## Product Change Notification

### PCN-AI-8473-2023

Business Unit	Product Line Code	Type of Change	Action	Date of Issue
AI - Automation Infrastructure	DNA	Product Change Notification	Notify Distributors and Field	1/18/2023

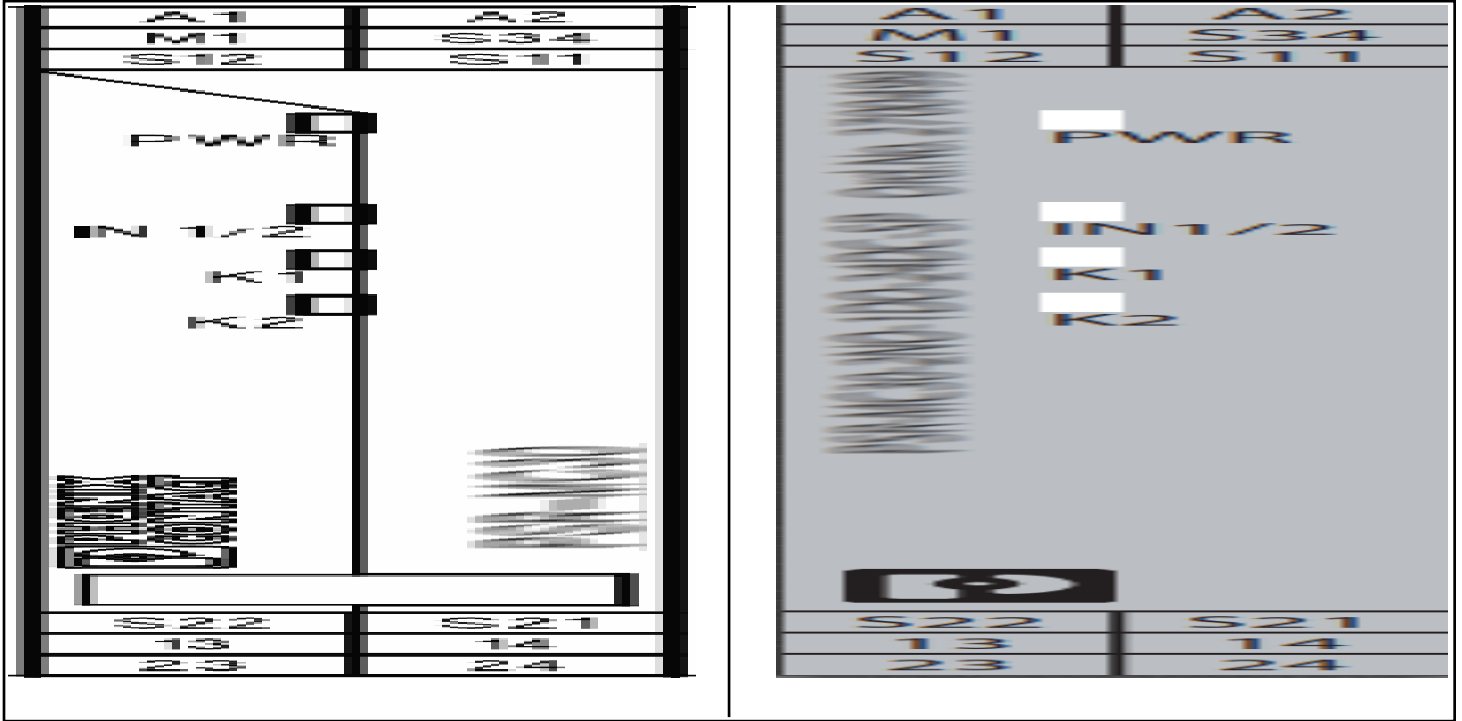
The change made to the item hardware requires an increase in the hardware revision for reasons of traceability. This improves the items' immunity to EMC. The technical properties, as described in the data sheets, remain unchanged.

In addition to the year of manufacture, the calendar week will be displayed below the CE mark. Furthermore, the marking on the front of the housing will be changed and the various pictograms / approvals will now be displayed in the lower area on the left half of the housing. The terminal blocks will longer be coded and the color of the terminal blocks will change from green to light gray (RAL 7035).
